Project	IEEE 802.16 Broadband Wireless Access Working Group < http://ieee802.org/16 >	
Title	Frame Structure to Support Multi-hop Relay Operation	
Date Submitted	2007-01-15	
Source(s)	<p>Wendy C Wong wendy.c.wong@intel.com Jerry Sydir jerry.sydir@intel.com Hannah Hyunjeong Lee Kerstin Johnsson</p> <p>Roger Peterson r.peterson@motorola.com Eugene Visotsky</p> <p>Masahito Asa asa@motorola.com</p> <p>Fang-Ching Ren frank_ren@itri.org.tw I-Kang Fu IKFu@ITRI.ORG.TW</p>	<p>Intel Corporation 2200 Mission College Blvd., Santa Clara, CA 95054, USA</p> <p>Motorola Labs 1301 E. Algonquin Road, Schaumburg, IL 60196 Motorola Japan Ltd., 3-20-1 Minamiazabu, Minatoku, Tokyo, 106-8573, Japan</p> <p>National Chiao Tung University/Industrial Technology Research Institute 1001 Ta Hsueh Road, Hsinchu, Taiwan 300, ROC</p>
Re:	This is a response to the call for proposals 80216j-06_034.pdf.	
Abstract	This contribution propose a frame structure to support multi-hop (≥ 2 hops) relay operation.

Frame Structure to Support Multi-hop Relay Operation

Figure xxx Example of minimum configuration for a multi-hop, in-band non-transparent relay frame structure

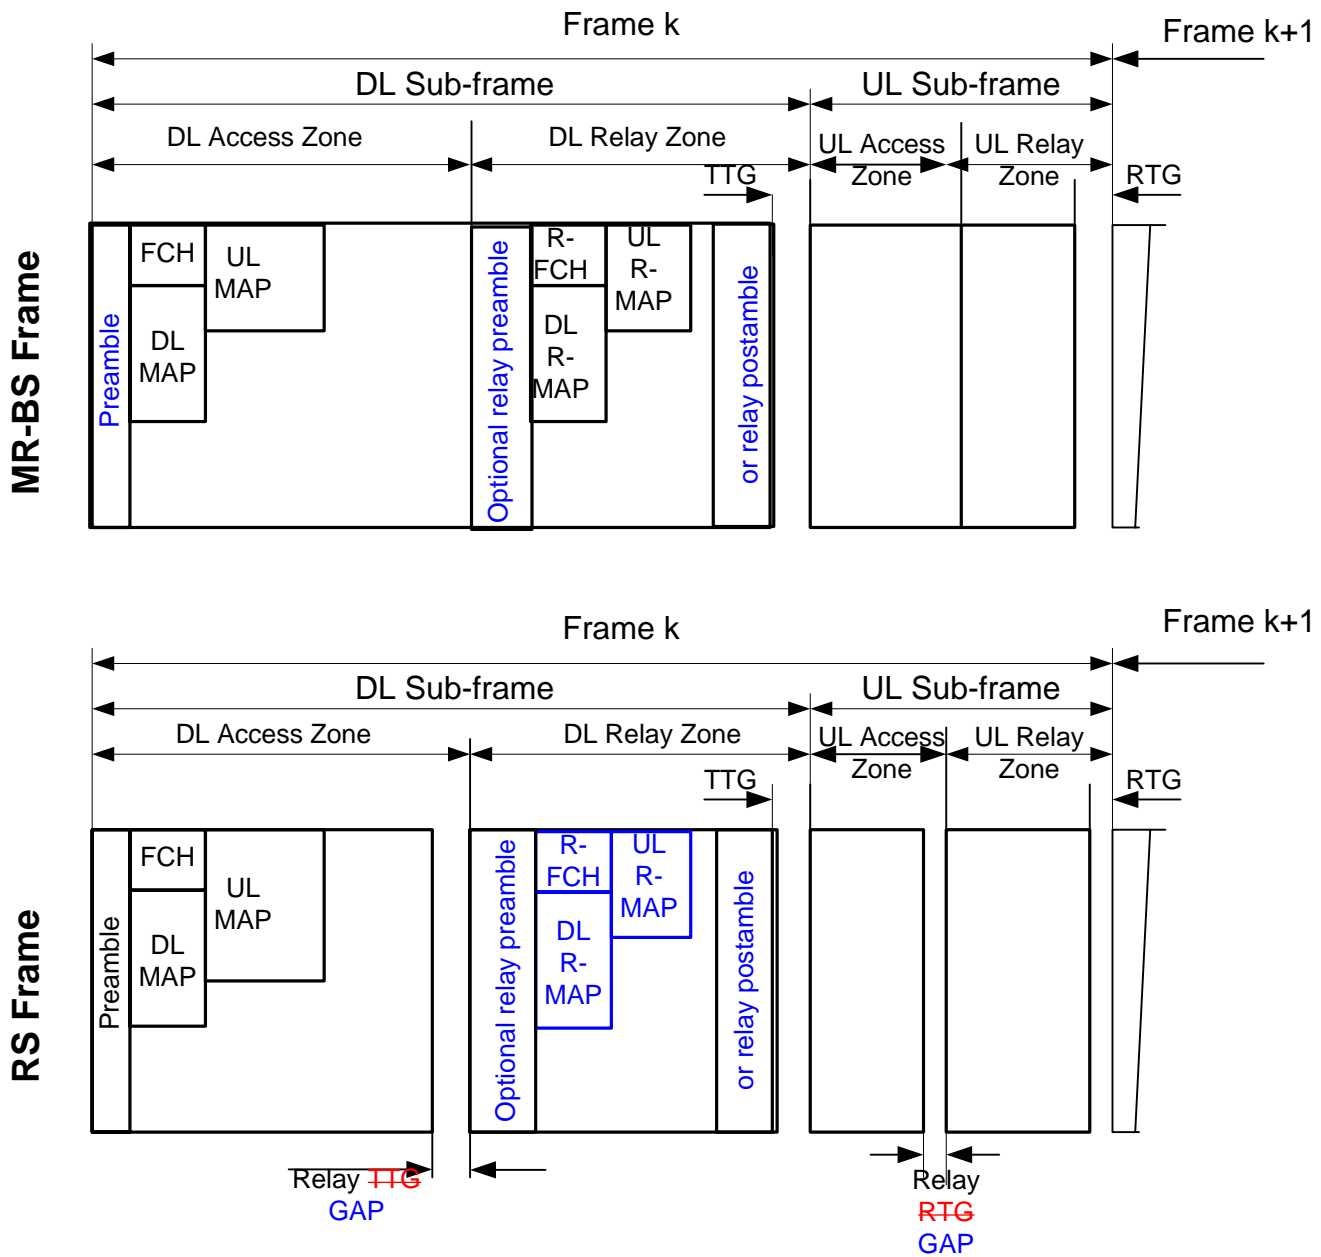
For the TDD mode, an example of the MR-BS frame structure is shown in Figure xxx.

Each MR-BS frame begins with a preamble followed by an FCH and the DL MAP and possibly UL MAP. The DL sub-frame shall include at least one DL Access Zone and may include one or more DL Relay_Zones. **The MR-BS shall be assigned to transmit or be idle in each of the DL Relay_Zones.** The UL sub-frame shall include at least one UL Access Zones and it may include one or more UL Relay_Zones. **The MR-BS shall be assigned to receive or be idle in each of the UL Relay_Zones.** In each frame, the TTG shall be inserted between the DL sub-frame and the UL sub-frame. The RTG shall be inserted at the end of each frame. In the DL Access Zone, the subchannel allocation, the FCH transmission, and the FCH shall be defined as in Section 8.4.4.2.

The DL Relay_Zone **may begin with a relay preamble** and shall include an R-FCH and an R-MAP. **The MR-BS may transmit a relay preamble and shall transmit R-FCH, and R-MAP in those DL Relay_Zones in which it is assigned to transmit.** The structure of the relay preamble shall be the same as specified in section 8.4.6.1.1. The set of preamble modulation sequences transmitted in the relay preamble shall be different from the preamble modulation sequences transmitted in the Frame Start Preamble. As an alternative, the MR-BS may transmit a relay postamble for each DL Relay_Zone at the end of the DL subframe following the end of the last DL Relay_Zone. **An R-Gap may be inserted between the last DL Relay_Zone and the first postamble and between postambles.. The structure of the relay postamble shall be the same as the relay preamble.** In the DL Relay_Zone, the subchannel allocation may be the same as that in the DL Access Zone. The R-FCH may be the same as the FCH in the DL Access Zone. Other attributes of the MR-BS frame and the RS frame such as transition between modulation and coding, presence of multiple zones, may be the same as those described in 8.4.4.2.

Figure yyy Example of an M frame MR-BS and RS ^k Super-Frames using relay preamble

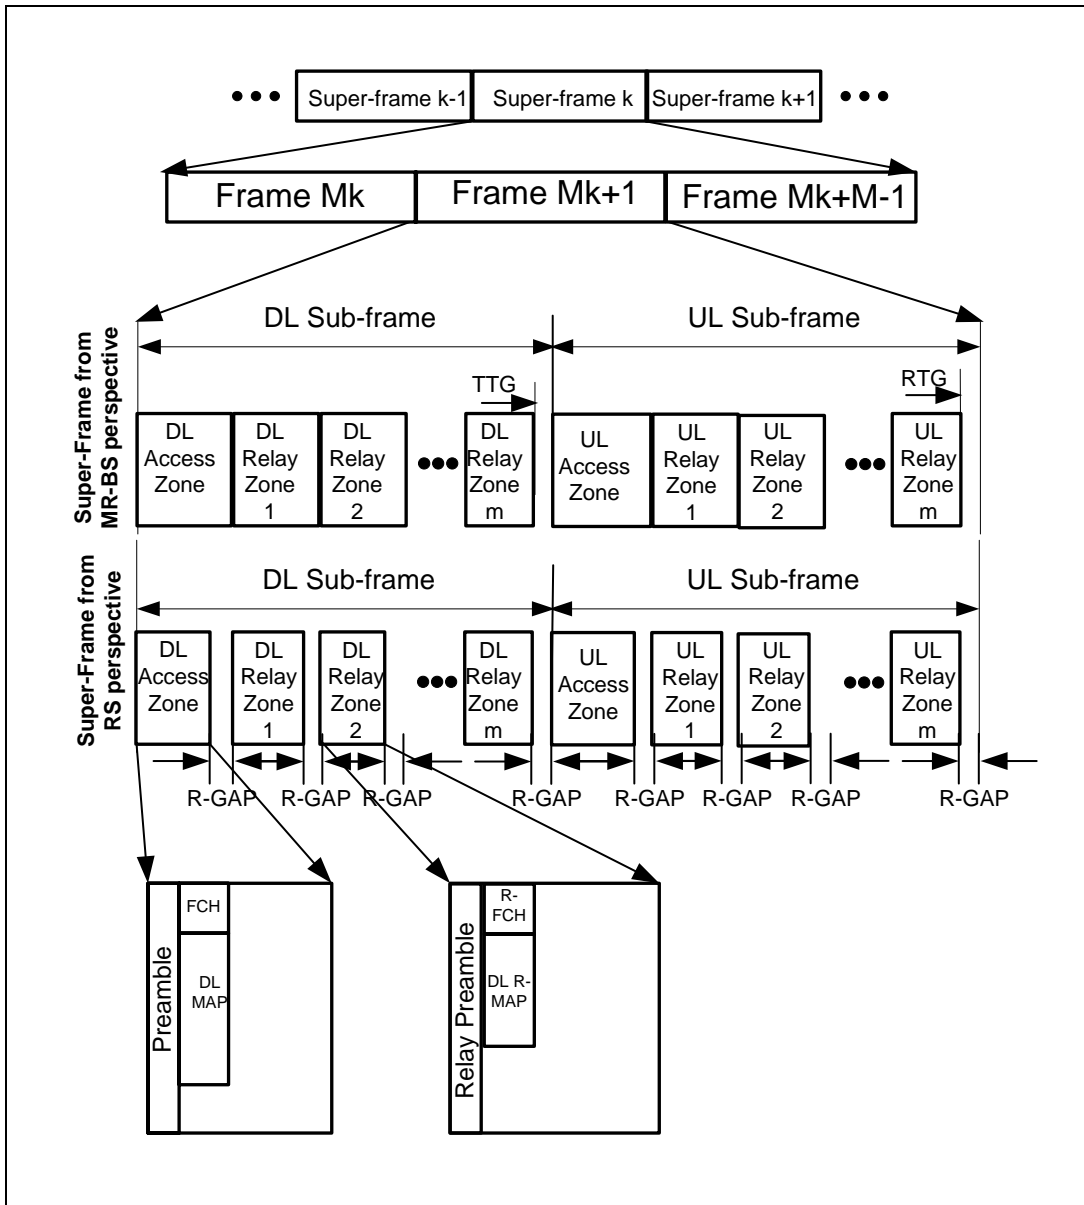
An example of an MR-BS and an RS super-frame is shown in figure yyy and figure zzz. This super-frame structure collapse back to the frame structure proposed in 8.4.4.7.2.1 and 8.4.4.7.2.2 when M is set to 1. One or more MR-BS frames may be grouped into an MR-BS super-frame. The number of MR-BS frames that make up an MR-BS super-frame shall be configurable. One or more RS frames may be grouped into an RS super-frame. The number of RS frames that make up an RS super-frame shall be configurable. The number of MR-BS frames that make up an MR-BS super-frame shall be the same as the number of RS frames that make up an RS super-frame.

The number of DL/UL Relay_Zones within a frame shall be configurable. The DL Relay_Zones within the MR-BS frames that make up an MR-BS super-frame shall be uniquely identified within the super-frame. When

super-frames are used, the MR-BS is assigned to either transmit or be idle in each of the DL Relay_Zones in the MR-BS super-frame.

The UL Relay_Zones within the RS frames that make up an RS super-frame shall be uniquely identified within the super-frame. When super-frames are used, an RS is assigned to either transmit, receive or be idle in each of the UL Relay_Zones in the RS super-frame.
